DRAWING AMENDMENTS

Title: CROSS CONNECTING STOP APPARATUS AND METHOD

Inventor: Michael A. Grillo
Date of Deposit: 25 June 2003
Atty. Dkt. No.: 100-1229

FIG. 2

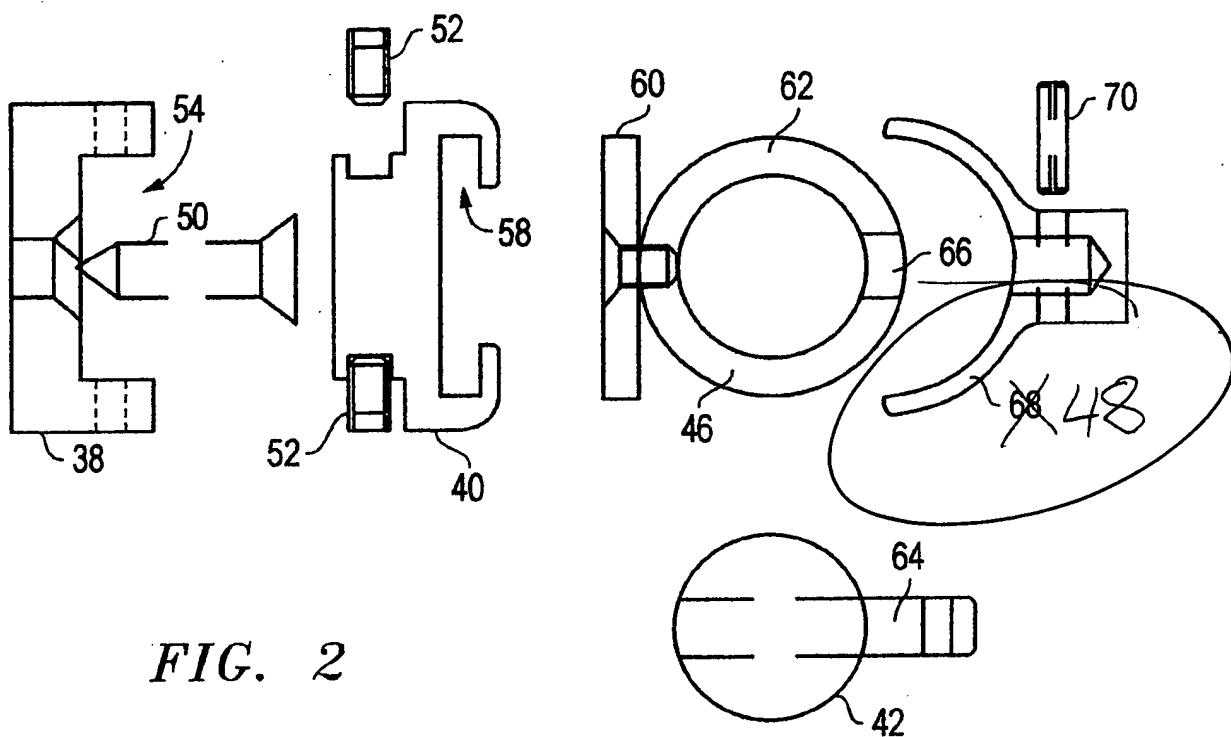
A proposed drawing correction is submitted wherein numeral "48" has been added to Figures 2 and 3 in place of the mistakenly used numeral "68" in those two figures. Further, a proper "Replacement Sheet" is submitted herewith.
